Addendum

Addendum Number:	ADD-03
Addendum Date:	02.09.21
Project Number:	20-035
Project Name:	Public Works Vehicle Storage Addition
Owner:	City of St. Charles, MO

1 ENCLOSED VEHICLE BUILDING – WATER & GAS PLAN – AREA B

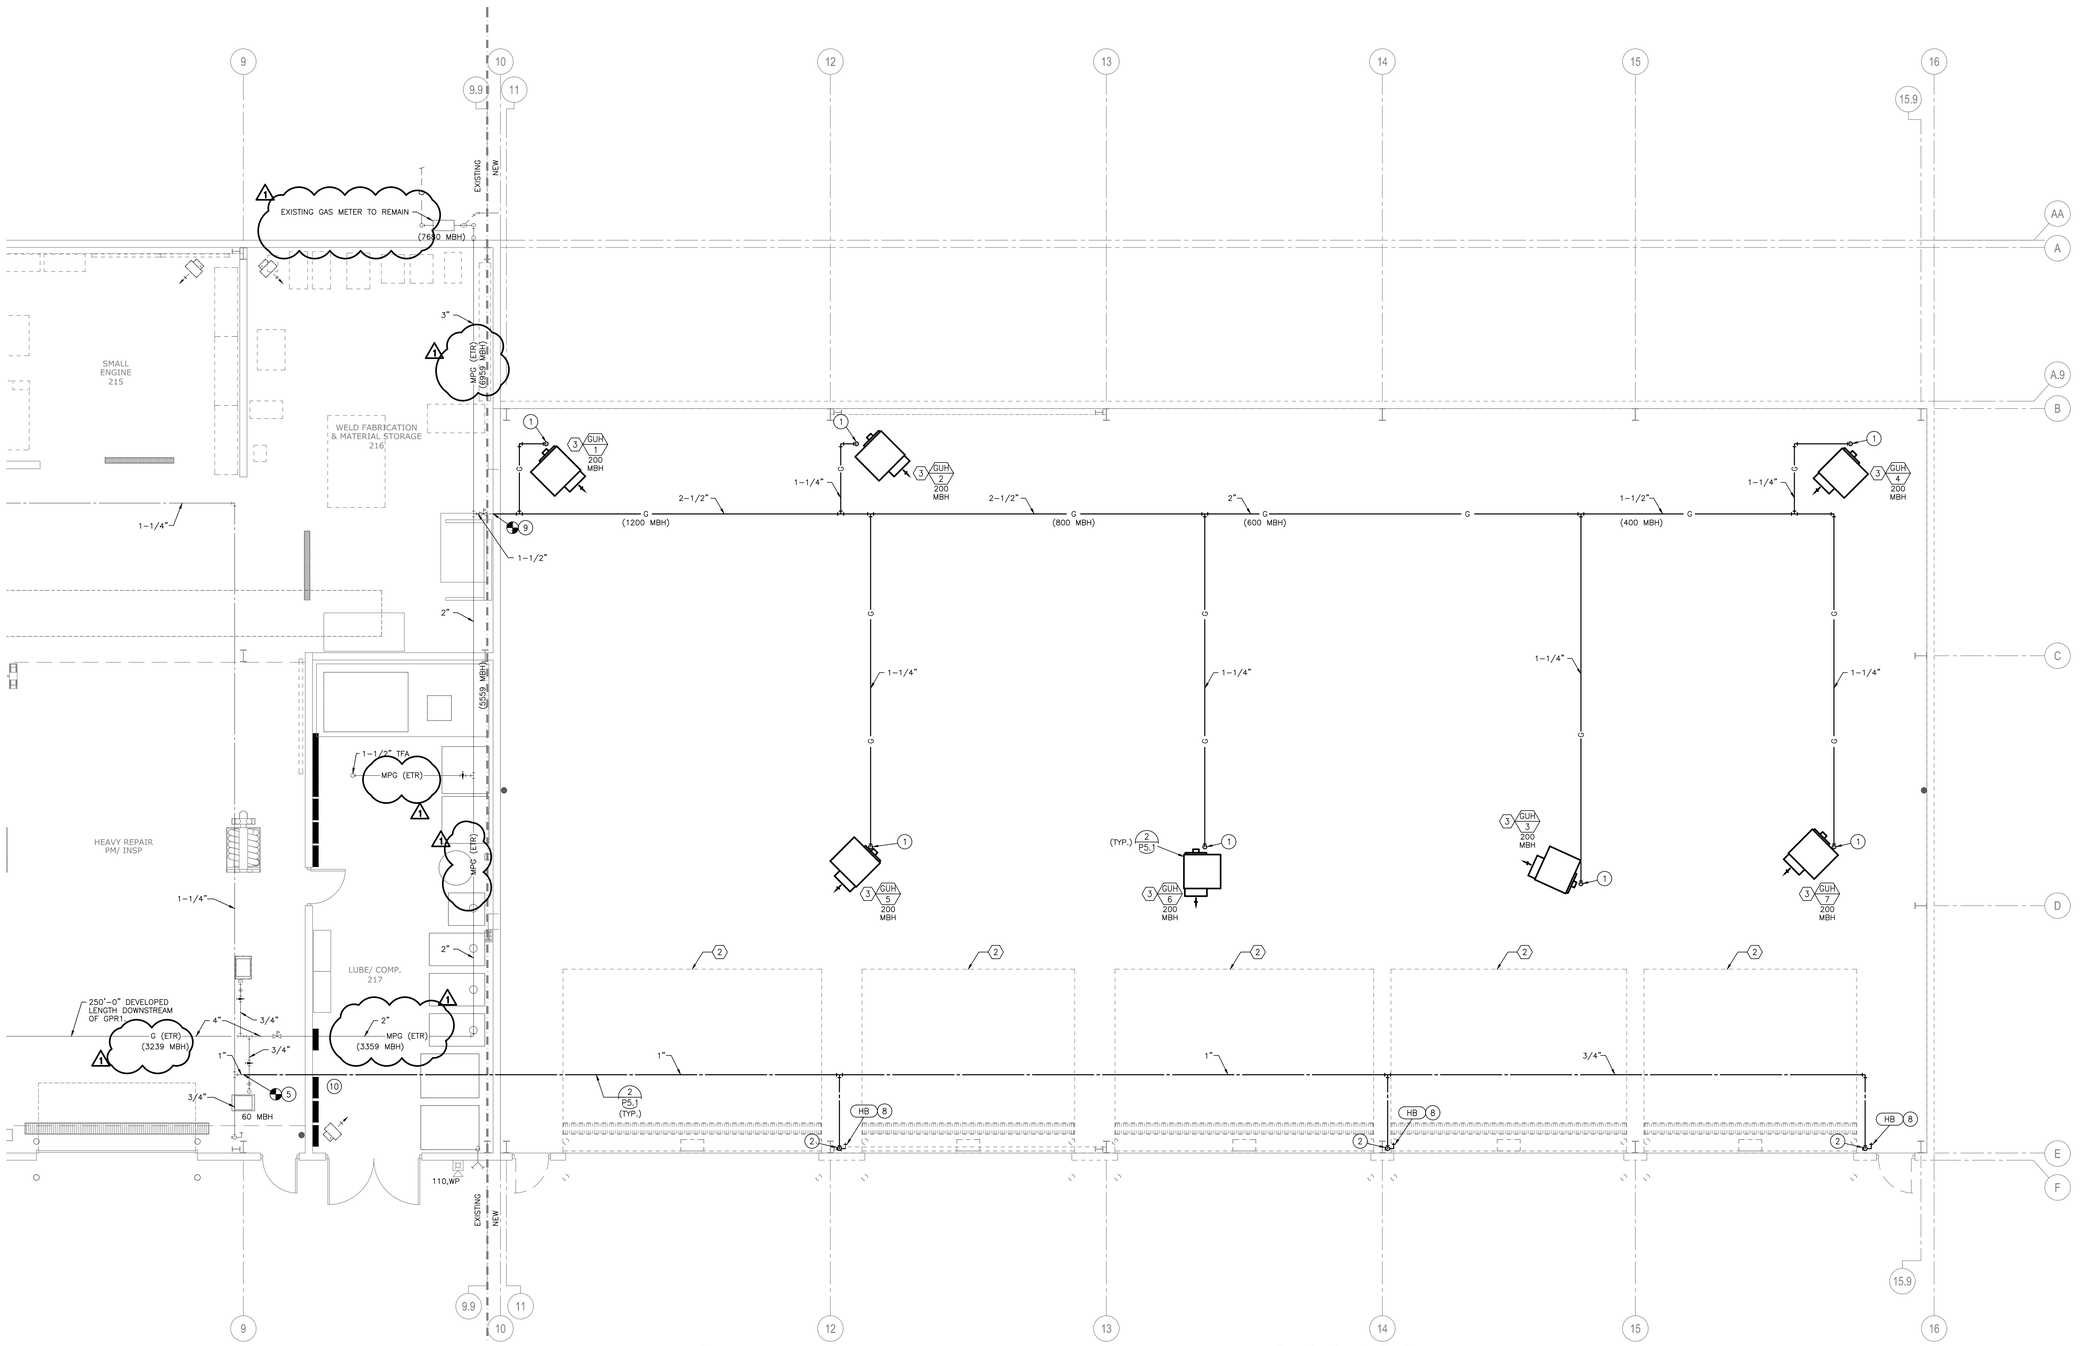
12. P2.4 Water & Gas Plan
    a. CLARIFICATION: Added “ETR” (Existing to Remain) notation to gas meter and to gas piping previously shown as existing to clarify existing vs new piping.
